ENVIRONMENTAL REVIEW COMMITTEE REPORT AND ADMINISTRATIVE SHORT PLAT REPORT & DECISION

ERC MEETING DATE:	October 11, 2010
Project Name:	Binder/Sibley Short Plat
Owner:	Patricia M. Binder; 980 Hoquiam Ave NE; Renton, WA 98059
Applicant:	Chris Sibley; 980 Hoquiam Ave NE; Renton, WA 98059
Contact:	Craig Krueger; DBA Land Planning; 733 7 th Ave #100; Kirkland, WA 98033
File Number:	LUA10-066, ECF, SHPL-A
Project Manager:	Rocale Timmons, Associate Planner
Project Summary:	<p>The applicant is requesting Administrative Short Plat approval and Environmental Review for an existing 89,225 square foot parcel to be subdivided into two lots with two tracts. Tract A, which contains three additional shadow lots, would be set aside for future development in order to satisfy the minimum density requirement of the zone. A 41,094 square foot, Category 3, wetland is present in the southwest portion of the site and would be placed within Tract B along with its buffer. The proposal with a total of five lots, including the three shadow lots located within Tract A, would arrive at a density of 4.05 dwelling units per net acre (du/ac). There is an existing house located on proposed Lot 1, which would be re

EXHIBIT 2

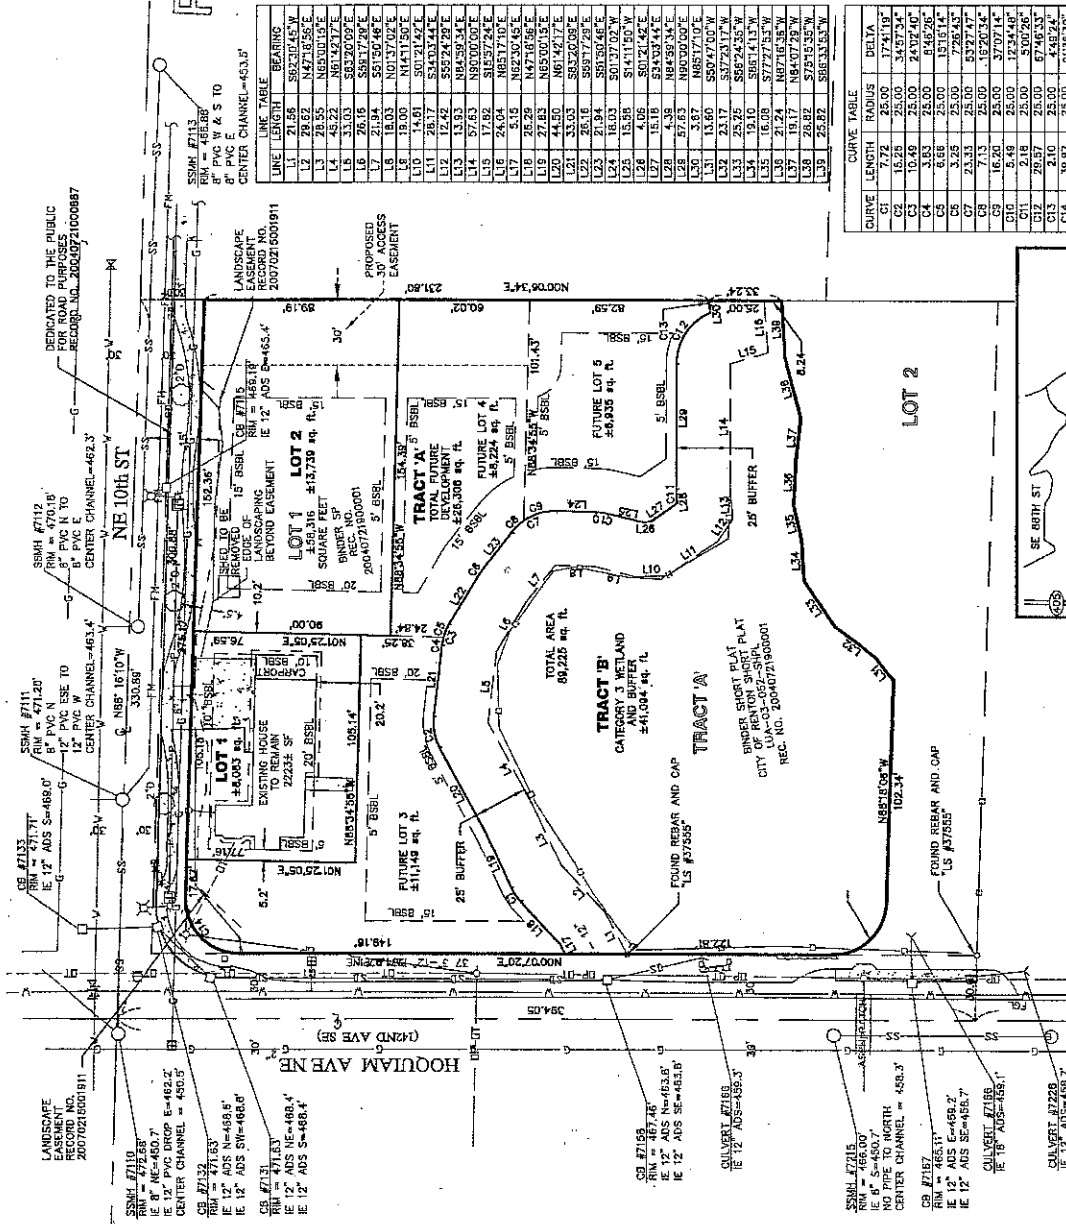
Note the City of Renton land use action number and land record number, LUA-10-066-SHPL and LND-20-0561 respectively, on the final short plat submittal. The type size used for the land record number should be smaller than that used for the land use action number.

Show two ties to the City of Renton Survey Control Network. The geometry will be checked by the city when two ties are provided (show ties to Survey Control Network Mons and Mon numbers.)

Provide sufficient information to determine how the short plat boundary was established.

Provide short plat and lot closure calculations.

Indicate what has been, or is to be, set at the new corners of the lots and tracts.

Note what was found when visiting the existing monuments.

Note discrepancies between bearings and distances of record and those measured or calculated, if any.

Note that the adjoining properties, easterly and southerly of proposed Lot 2 and Tracts 'A' and 'B', are platted (note the plat name and lot numbers on the short plat drawing).

Note the addresses for both lots on the short plat submittal. The address for proposed Lot 2 will be provided by the city as soon as possible.

On the final short plat submittal, remove all references to utilities facilities (utilities lines, culverts, manholes, catch basins, etc.) and other items not directly impacting the subdivision. These items are provided only for preliminary short plat approval.

Remove the "ZONING" block from Sheet 1 of 1.

Remove the building setback lines from all lots and tracks.

Remove the future lot lines within Tract 'A', since the configuration of the lots could change before said lot lines are finally defined. Also, remove the "3 FUTURE DEVELOPMENT LOTS" block.

Remove the second item under "SURVEY NOTES". Said item does not directly impact the short plat.

Do note encroachments, if any.

All vested owner(s) of the subject short plat, at the time of recording, need to sign the final short plat submittal. Include notary blocks as needed.

Note an appropriate declaration block on Sheet 1 of 2, and title it "OWNER'S DECLARATION".

The City of Renton Administrator of Public Works is the only city official who signs the short plat submittal. Provide an appropriate approval block and signature line for his use. Pertinent King County approval blocks are also needed as required.

Is a Native Growth Protection Easement needed for this short plat submittal?

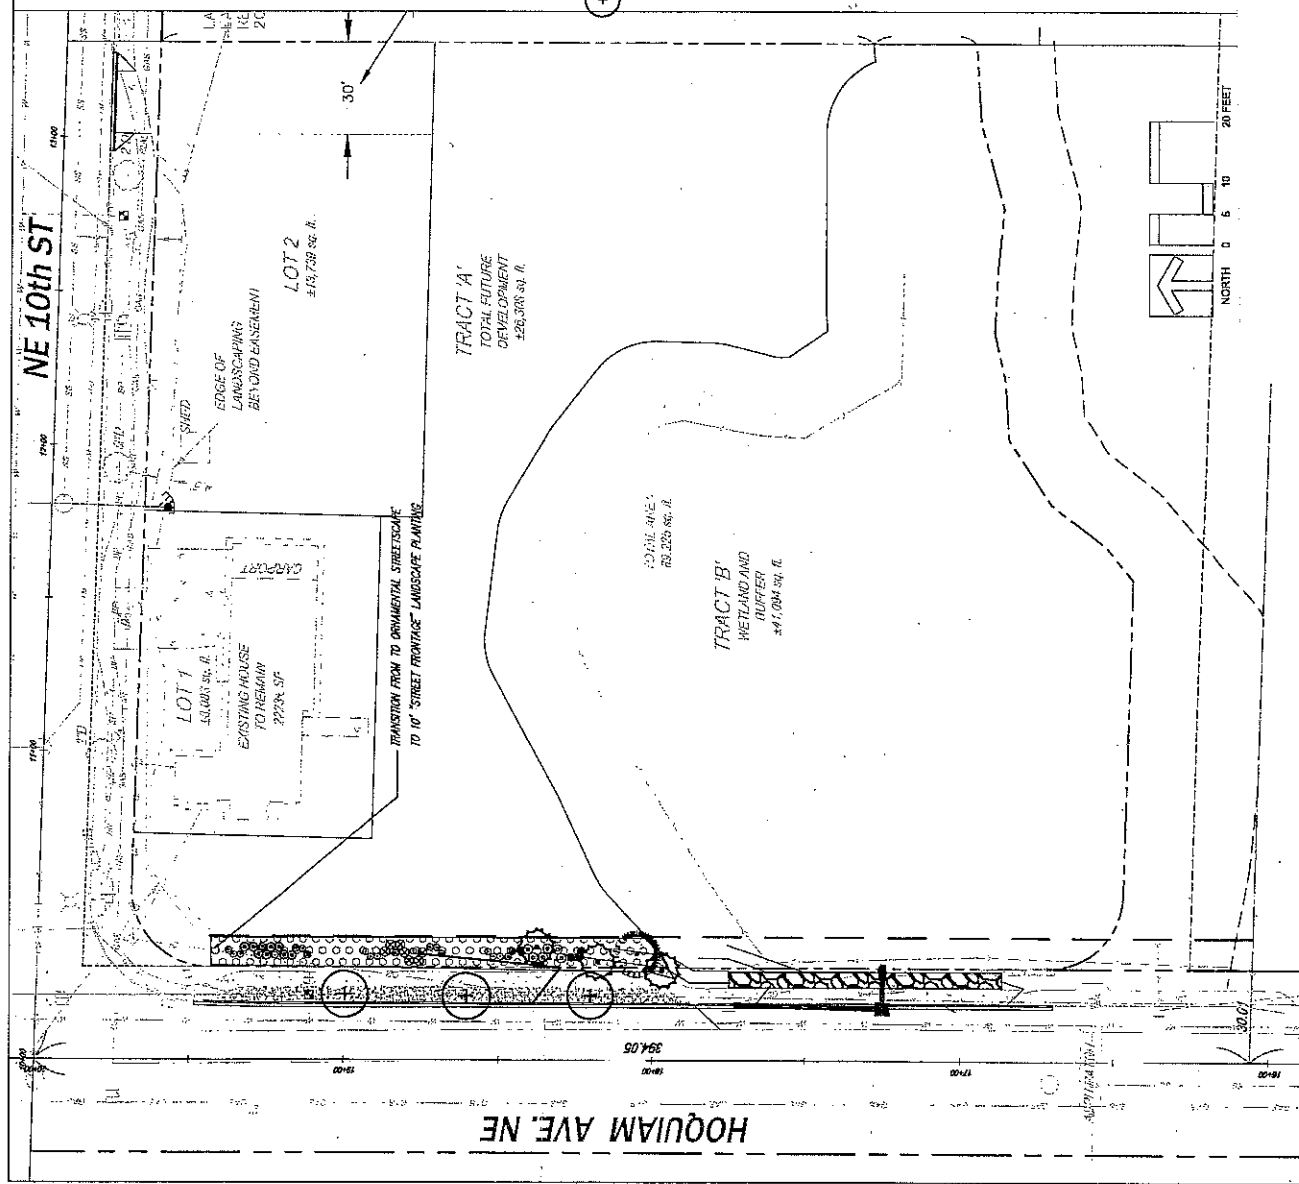
<i>excluded area, are proposed for retention which complies with the tree retention requirement. The applicant will be required to comply with protection measures for retained trees as set forth in RMC 4-4-130H8.</i>
Not Compliant	<p>Landscaping: Ten feet of on-site landscaping is required along all public street frontages, with the exception of areas for required walkways and driveways.</p> <p>Staff Comment: Currently the site consists of a variety of vegetation, including alder, cottonwood, fruit, walnut, fir, and cedar trees outside of the wetland on site. A conceptual landscape plan was submitted with the application. The proposal includes the installation of three dogwood trees within the landscaping provided in between the street and the sidewalk along Hoquiam Ave NE. There is a 10-foot landscape strip proposed abutting the Hoquiam Ave NE. Vegetation with the landscape strip includes 3 vine maple trees and 1 Douglas fir tree. Shrubbery consists of redbud dogwood, salal, sword fern, Oregon grape, and red flowering current. While the applicant has proposed a good mixture of vegetation it is unclear as to why there are no trees located in the northern portion of the landscape strip. Additionally, the applicant has noted that existing landscaping, on site, would be used to augment the 10-foot wide landscape strip frontage requirement along NE 10th St. However, landscaping along NE 10th St was not depicted on the conceptual landscape plan. Therefore staff recommends, as a condition of approval, the applicant submit a revised landscape plan with additional trees in the northern portion of the landscape strip along Hoquiam Ave NE and depict a 10-foot wide landscape strip (existing or proposed) along NE 10th St. The revised landscape plan shall be submitted to and approved by the Current Planning Project Manager prior to short plat recording.</p>

2. The applicant shall submit a revised landscape plan with additional trees in the northern portion of the landscape strip along Hoquiam Ave NE and depict a 10-foot wide landscape strip (existing or proposed) along NE 10th St. The revised landscape plan shall be submitted to and approved by the Current Planning Project Manager prior to short plat recording.
